TITLE: POWER CONN 4.20MM PITCH		HOMETOM www.hometom.com.tw HONG TONG ENTERPRISE CO.,LTD.	
TOLERANCE		APPROVAL: <i>陈友明</i>	UNIT: mm
LINEAR: X. ±0.30 .X ±0.25 .XX ±0.20	ANGLE: X° ±2° X° ±1° .XX° ±0.5°	CHECK: <i>王</i>	PART NO: PW**W5***P026
CUSTOMER DRAWING	REV: P	DRAWN: <i>王</i>	SIZE: A4
		SCALE: 1:1	DWG.NO: CPW039-00
		PRJ.:	SHEET: 1 / 3

深圳市紘通电子有限公司 變更通知(ECN)

<input type="checkbox"/> 制程變更 <input type="checkbox"/> 設計變更 <input type="checkbox"/> 有害物質變更 <input checked="" type="checkbox"/> 其它 _____				ECN編號: BN22102401				
品名		POWER CONN 4.20MM PITCH				ECR編號:		
料號		PW**W5***P026		變更目的		Change 24P packing		
版次		(0) → (P)		頁數		3		
关联文件 <input checked="" type="checkbox"/> 成品图 <input type="checkbox"/> 零件图 <input type="checkbox"/> SOP <input type="checkbox"/> SIP <input type="checkbox"/> BOM <input type="checkbox"/> 其它 _____								
修正資料 版本	成品图 Rev: 0		零件图 Rev:		SOP Rev:		SIP Rev:	
	NO. : CPW039-00		NO. :		NO. :		NO. :	
	<input checked="" type="checkbox"/> 发行新版本 Rev : P		<input type="checkbox"/> 发行新版本 Rev :		<input type="checkbox"/> 发行新版本 Rev :		<input type="checkbox"/> 发行新版本 Rev :	
	<input type="checkbox"/> 沿用旧版本 Rev :		<input type="checkbox"/> 沿用旧版本 Rev :		<input type="checkbox"/> 沿用旧版本

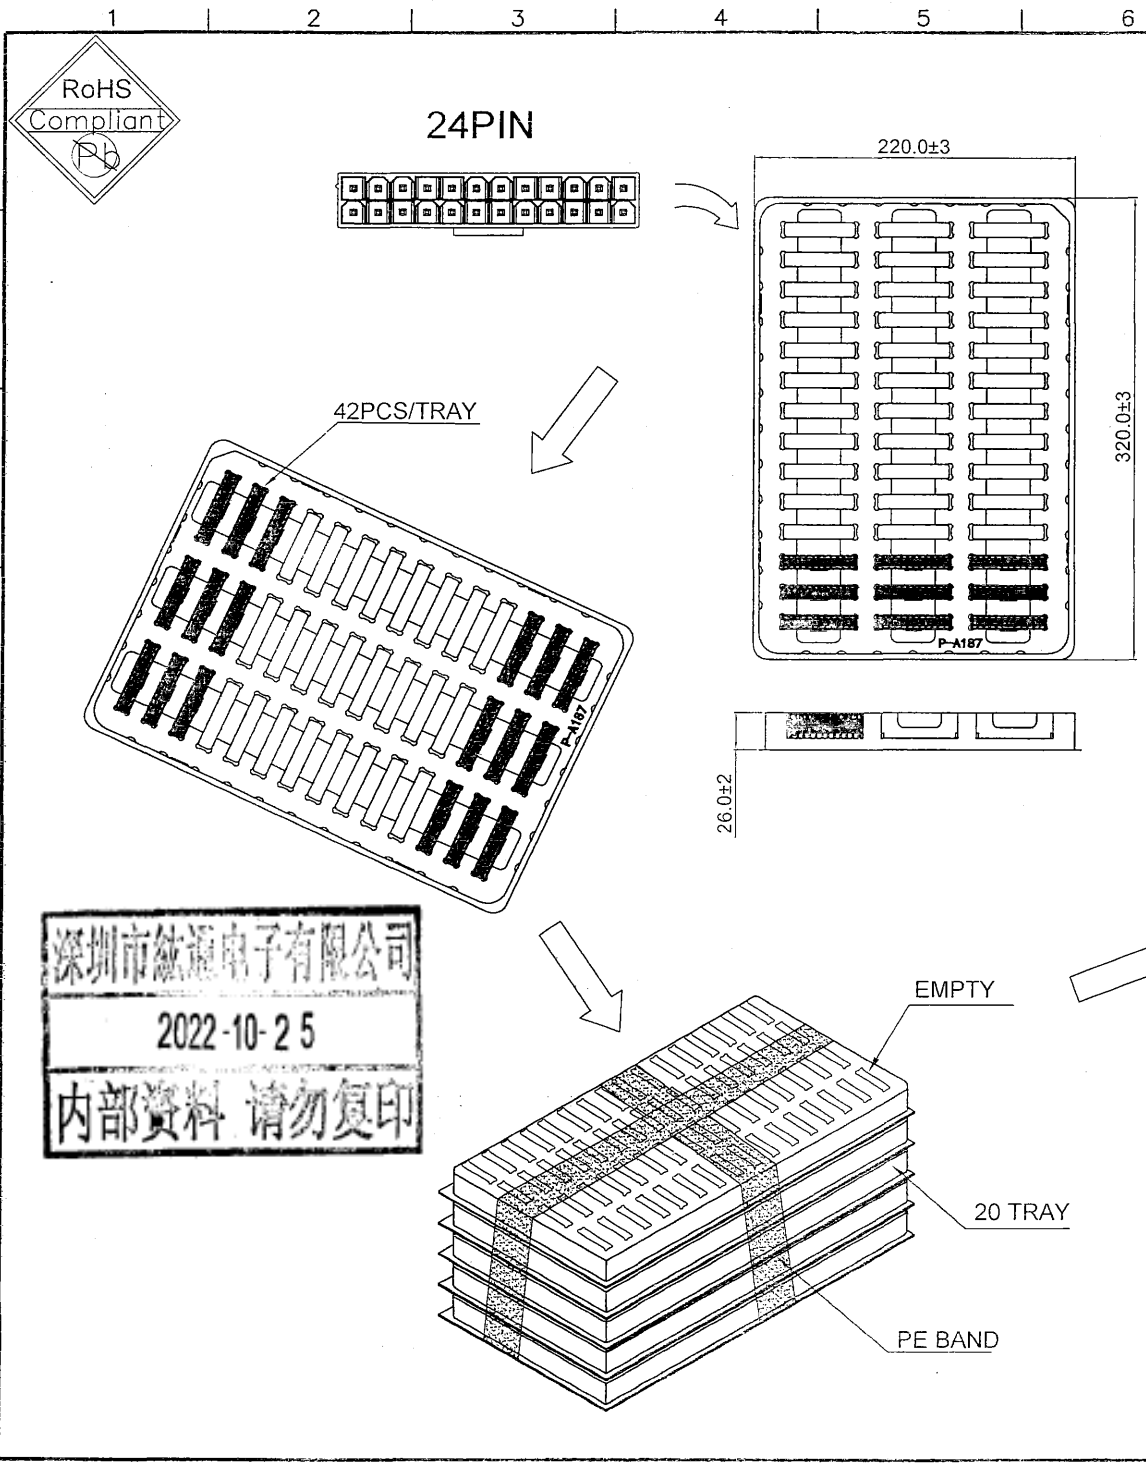
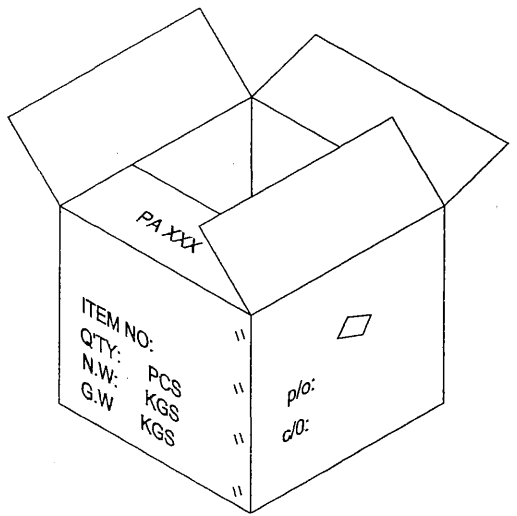
REV.	ECN NO.	DESCRIPTION	DWN.	APVD.	DATE
O	BN16082901	Add Color code	srigan	DLQ	2016/08/29
P	BN22102401	Change 24P packing	DLQ	DLQ	2022/08/31

2.QUANTITY:
 24Pin: 42 PCS/ TRAY
 20 TRAY/ CARTON
 840 PCS/ CARTON

Before the change

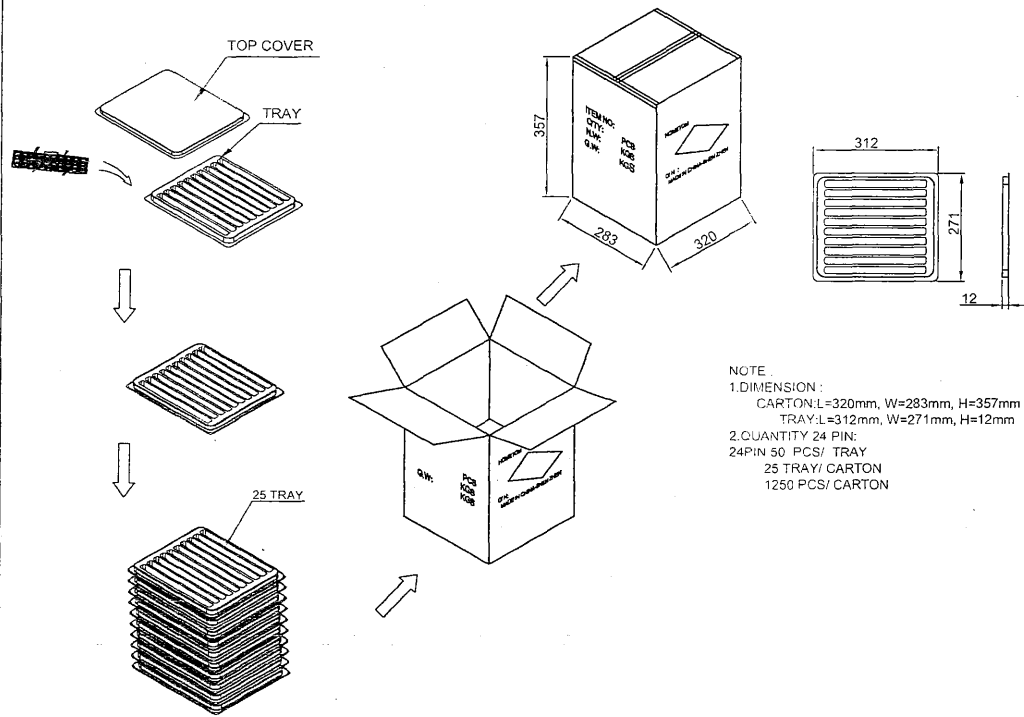
QUANTITY: 1250PCS/CARTON
TRAY: P-A001-N
CARTON: P-F001

After the change

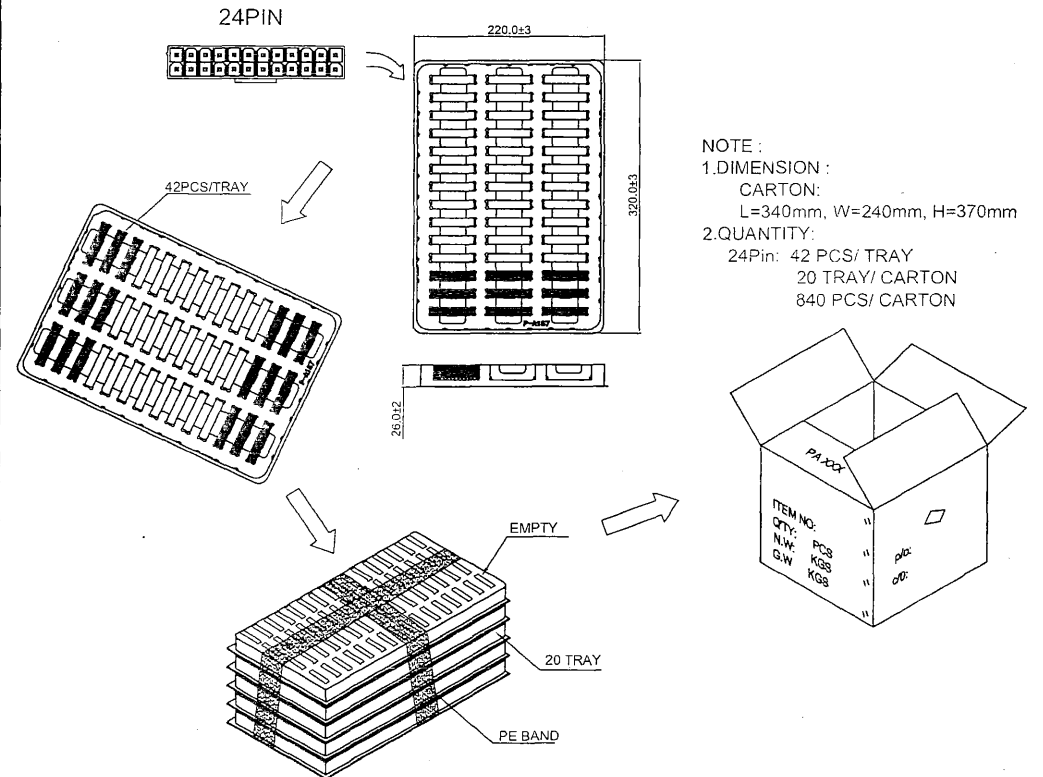
QUANTITY: 840PCS/CARTON
TRAY: P-A187
CARTON: P-F337
